Our Case Number: ACP-324624-26

Re: Proposed 16-Unit Residential Development at Páirc na hAbhainn, Athenry, Co. Galway

Case Reference: JP07.324624

Subject: Formal Submission and Observation Opposing the Proposed Development

NARROW STREETS IN PÁIRC NA hABHAINN
WITH RESIDENTS' CARS PARKED ON ONE SIDE,
THERE IS NOT ENOUGH SPACE FOR TWO CARS TO PASS.

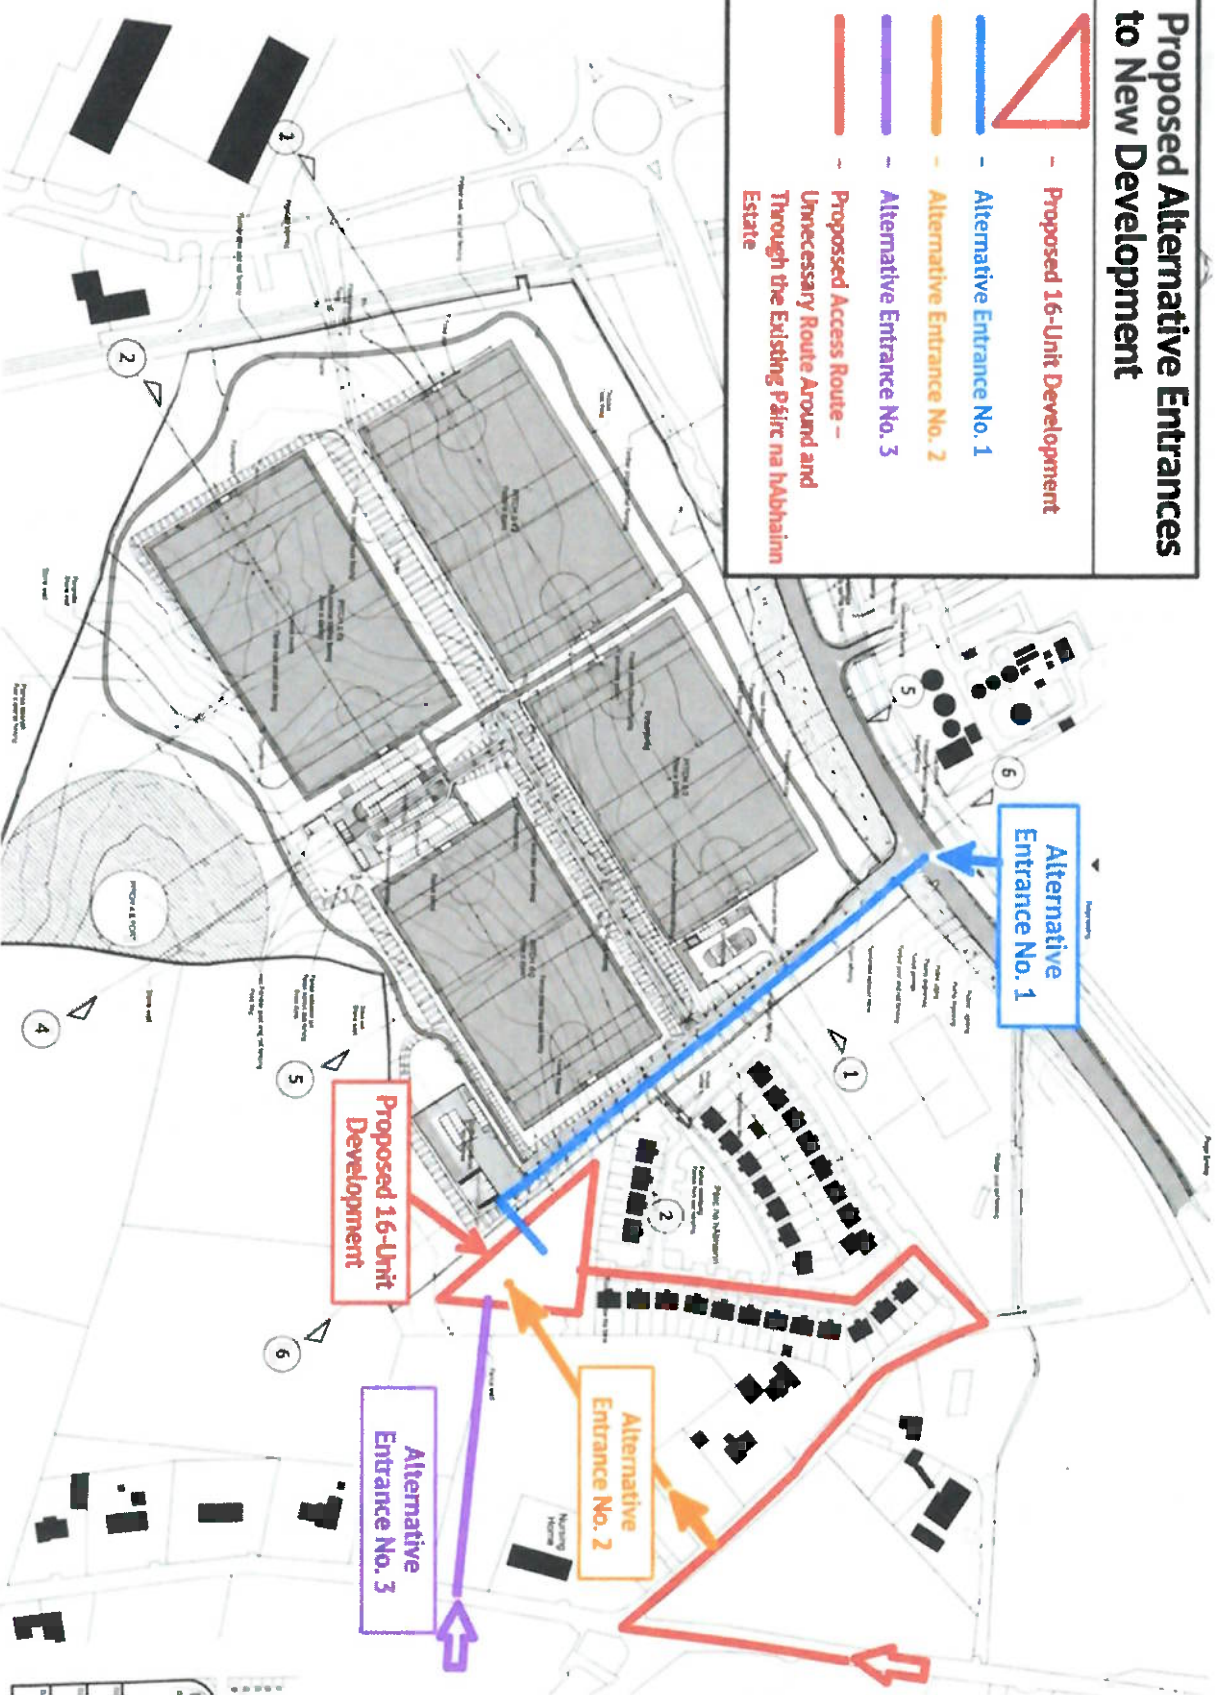
THIS CREATES SAFETY RISKS, CONGESTION
AND NEIGHBOURS' FRUSTRATION.
